Re: AAA Roofing Storage Space
2509 Comanche Rd. NE
Traffic Circulation Layout
Architect's Stamp dated 12-09-16 (G16-D004)

DRAINAGE AND TRANSPORTATION INFORMATION SHEET (REV 11/2016)

SITE PLAN / TRAFFIC CIRCULATION LAYOUT

AAA ROOFING STORAGE SPACE

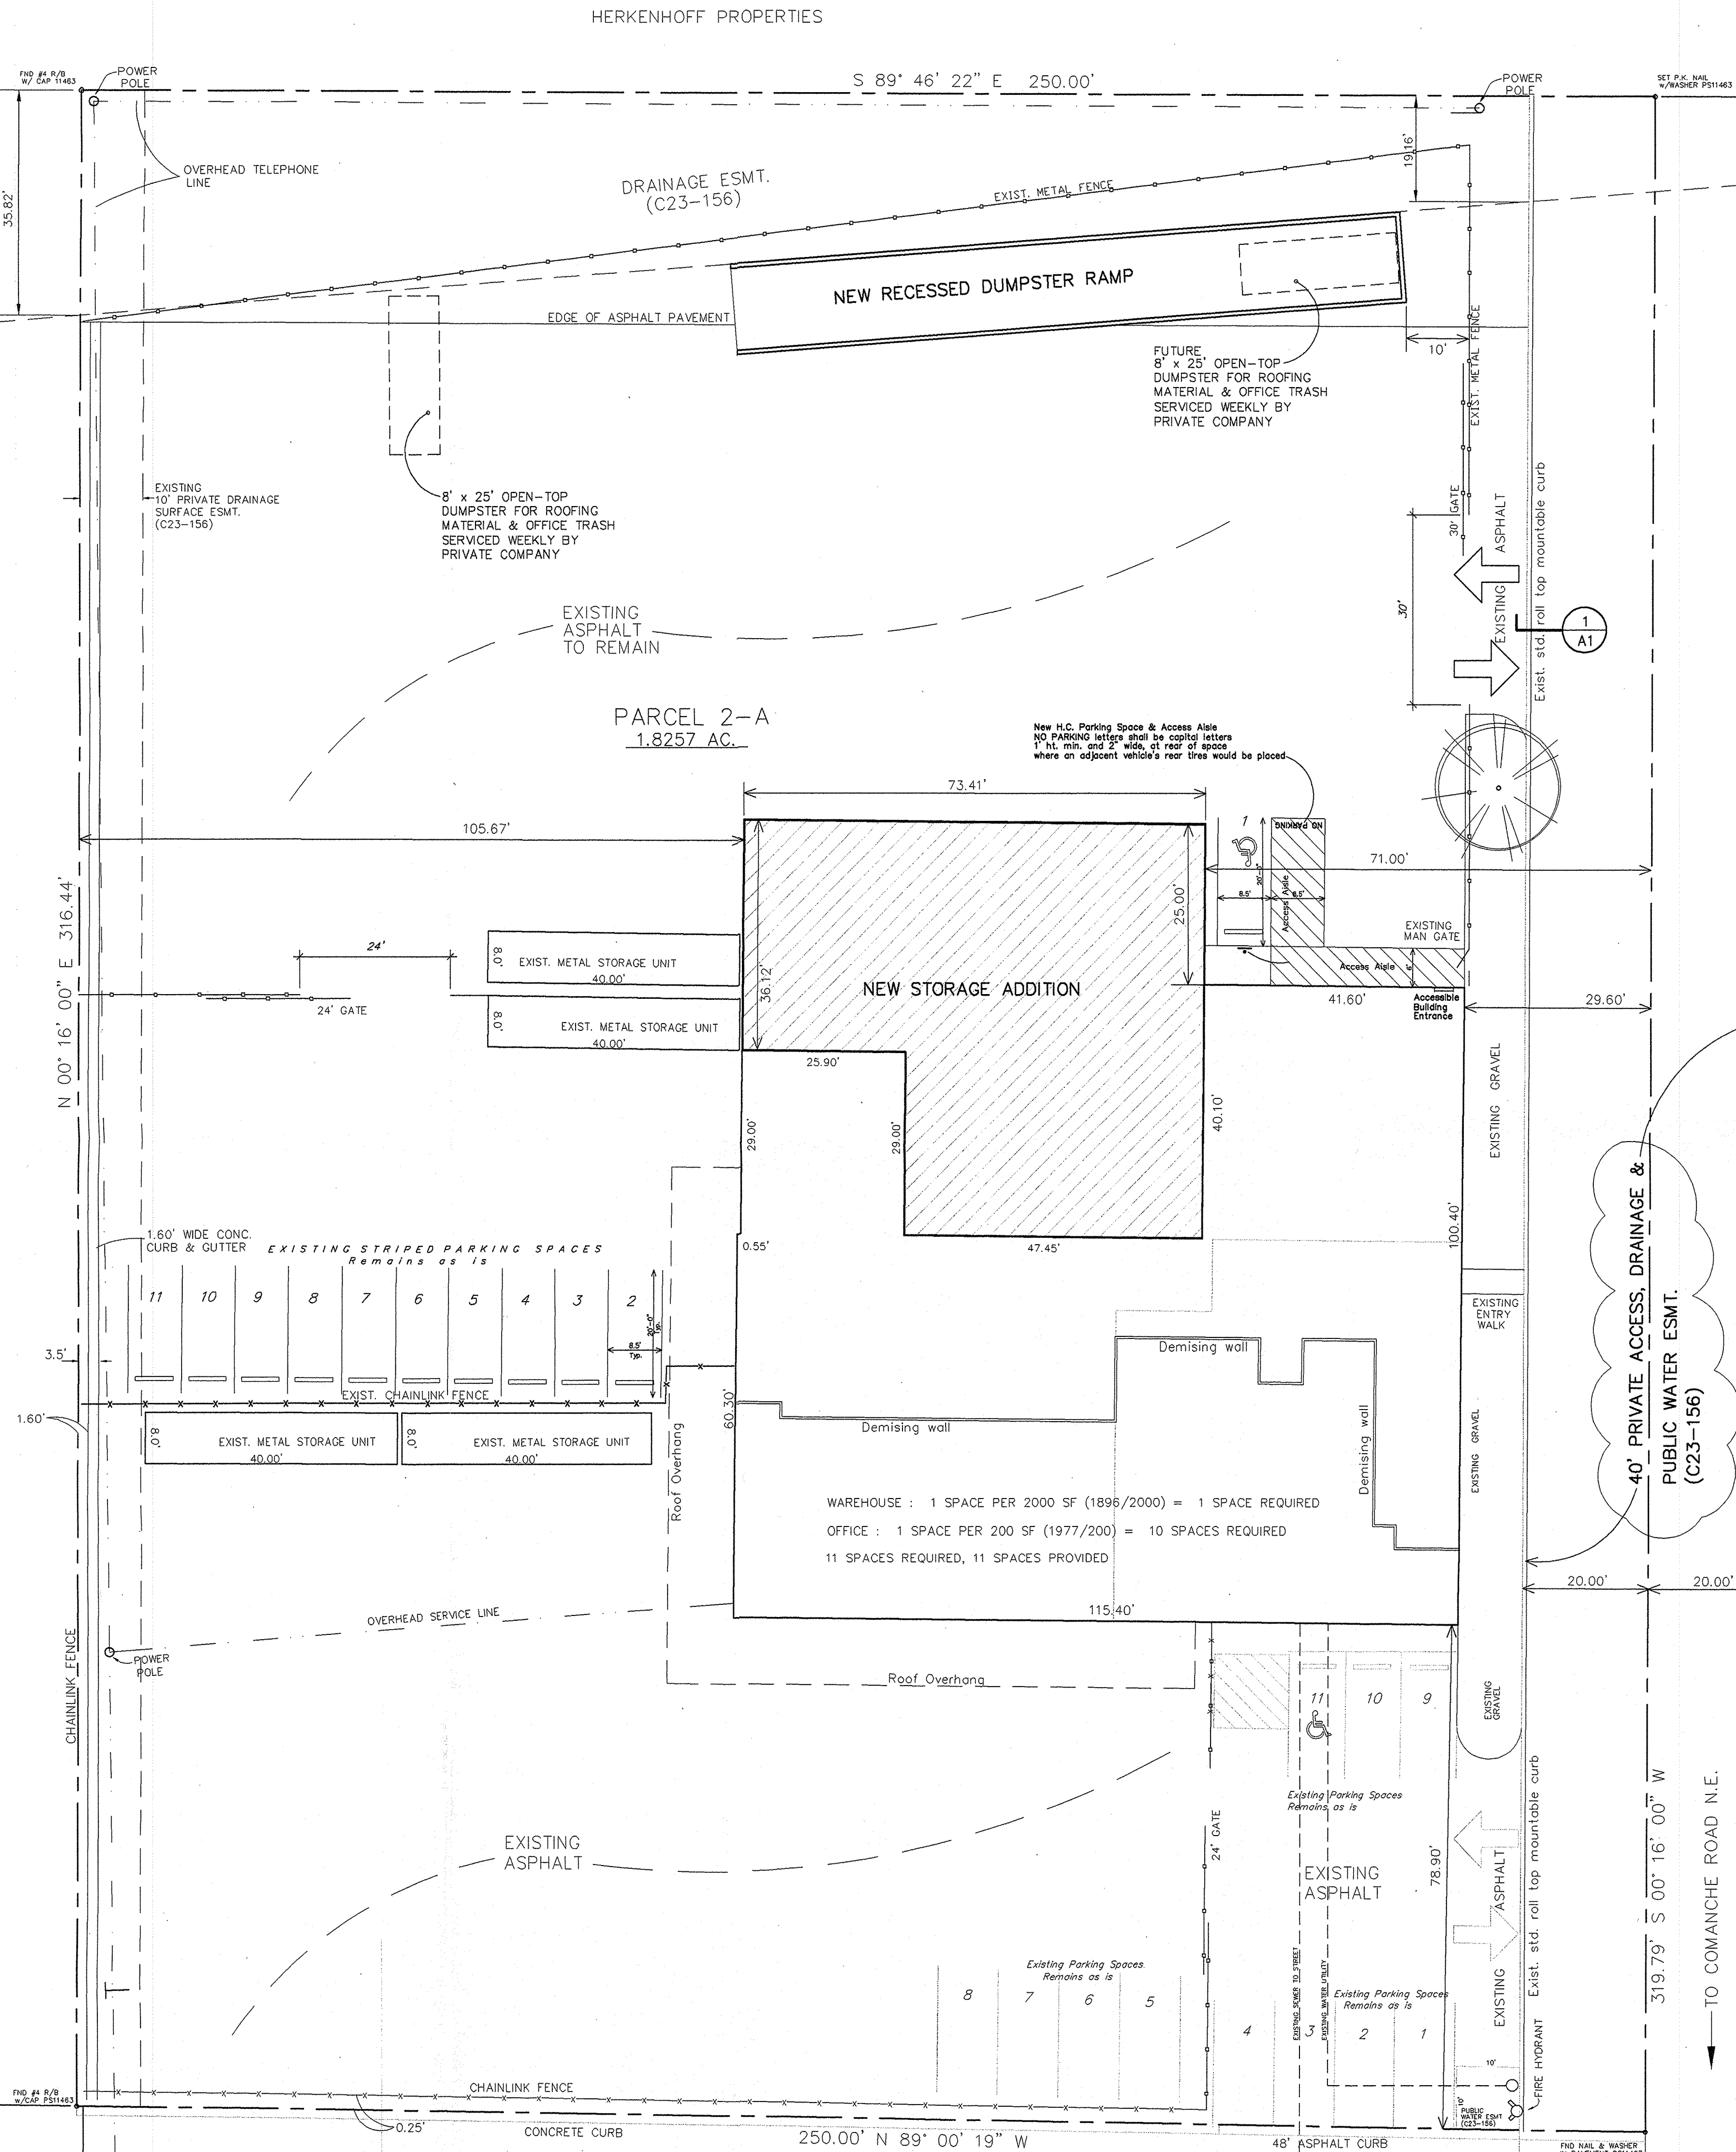
ALL WHEELCHAIR RAMPS LOCATED
WITHIN THE PUBLIC RIGHT OF WAY
MUST HAVE TRUNCATED DOMES.
